HOMESTEAD NORTH PHASE I PRELIMINARY PLAN

LETTER OF INTENT

~~NOVEMBER, 2020~~ REVISED MARCH 2021

LOI V_2 planning only redline.pdf Markup Summary 4-16-2021

LOCATION

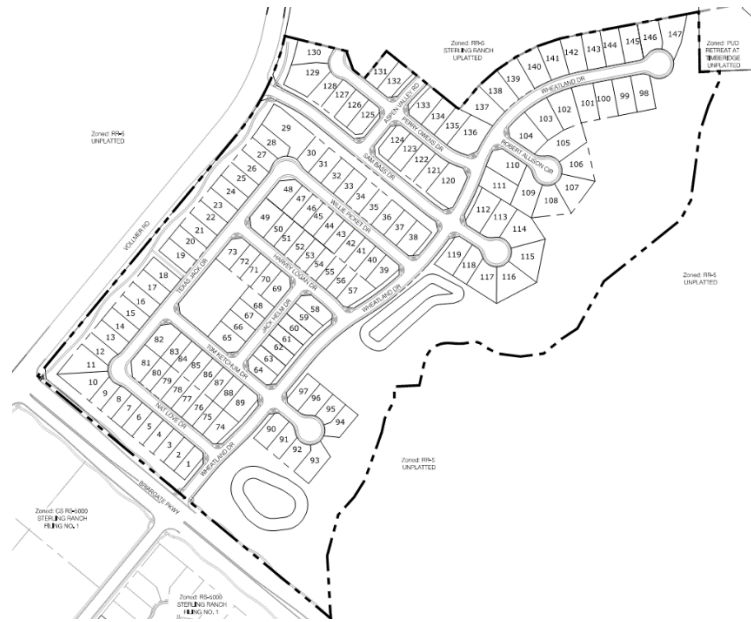
The Preliminary Plan was to request the authorization of the construction of Briargate BLVD and Sterling Ranch Road also to include the channel crossings. Can you adjust your request, project description and graphics to depict that? Separate CDs are being requested for approval of those improvements under this Preliminary plan if approved by the BOCC.
